PROJECT CUPRESSUM CROSS

Subject: War Memorial

SODC - Emily Karav B 01491 823059
Cuddesdon + Denton
Parish Council's subcommittee managing project
Application: P14/S3425/FUL
Refurbishment + relocation of village cross

Cuddesdon War Memorial
Options A and B

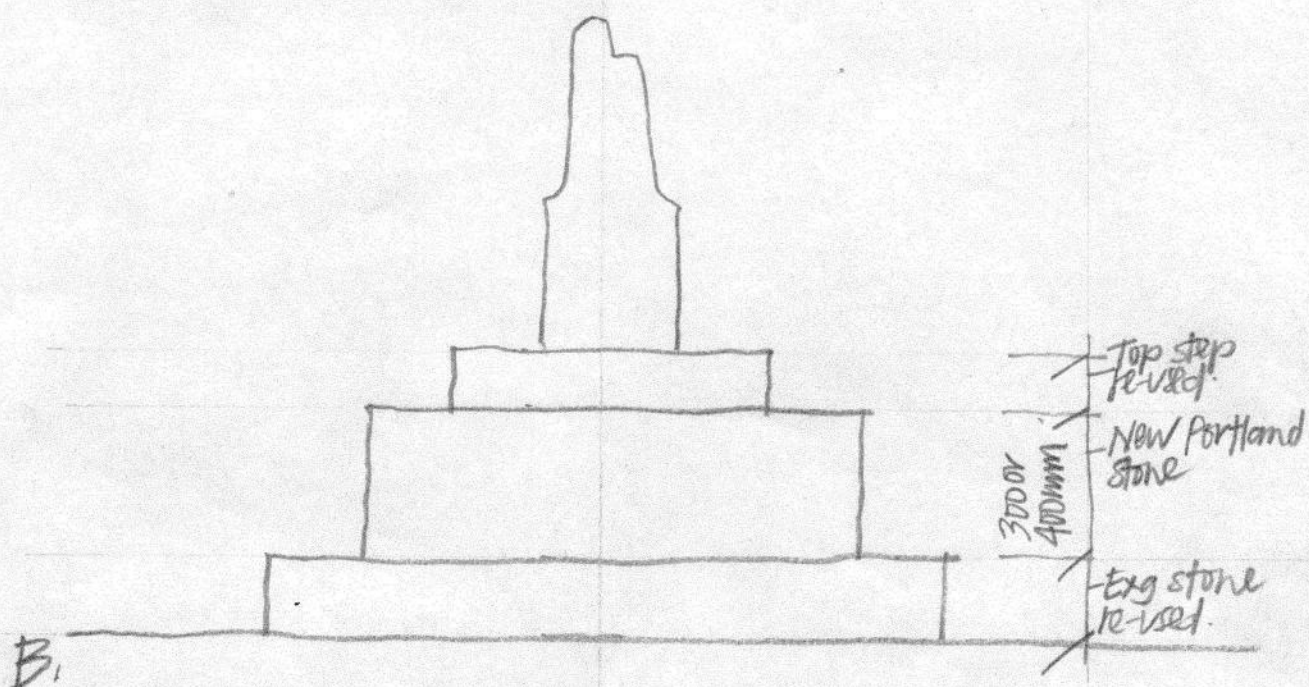
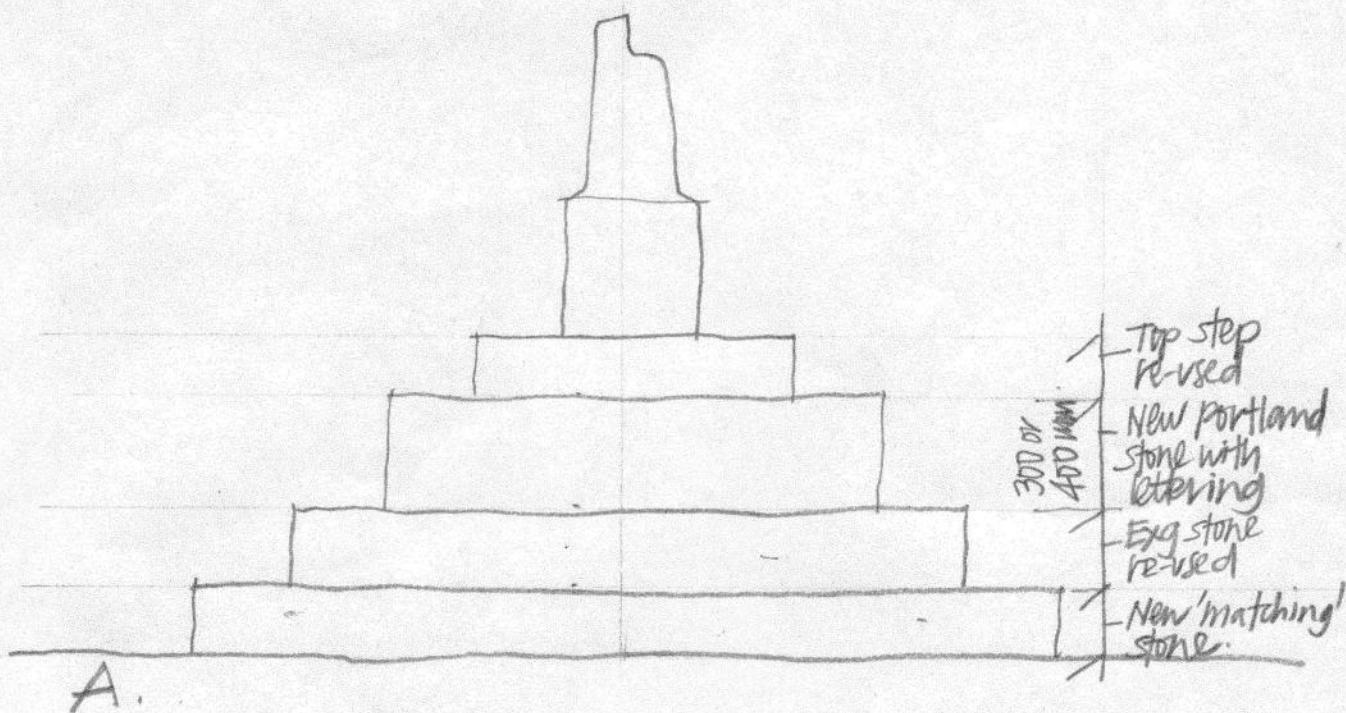
1. Omit new Portland Stone inscribed step - we propose a single inscribed block of Clipsham Stone, positioned centrally. The names of the dead will be on a separate stone 'block'..
2. Conserve and re-use existing stone (rather than replace) wherever possible - if stone has to be replaced use recycled Wheatley Limestone (as used in existing cross)

1. omit new Portland stone inscribed step - add
a single inscribed block of Clipsham stone
centrally positioned, names of dead on separate
block
2. conserve and re-use exg stone wherever possible
we would use Wheatley Limestone.

Amended plans 2/3 weeks extension
Send new plans direct to her at
emily.karav@southandvale.gov.uk.

Proposed class + plan only reqd.
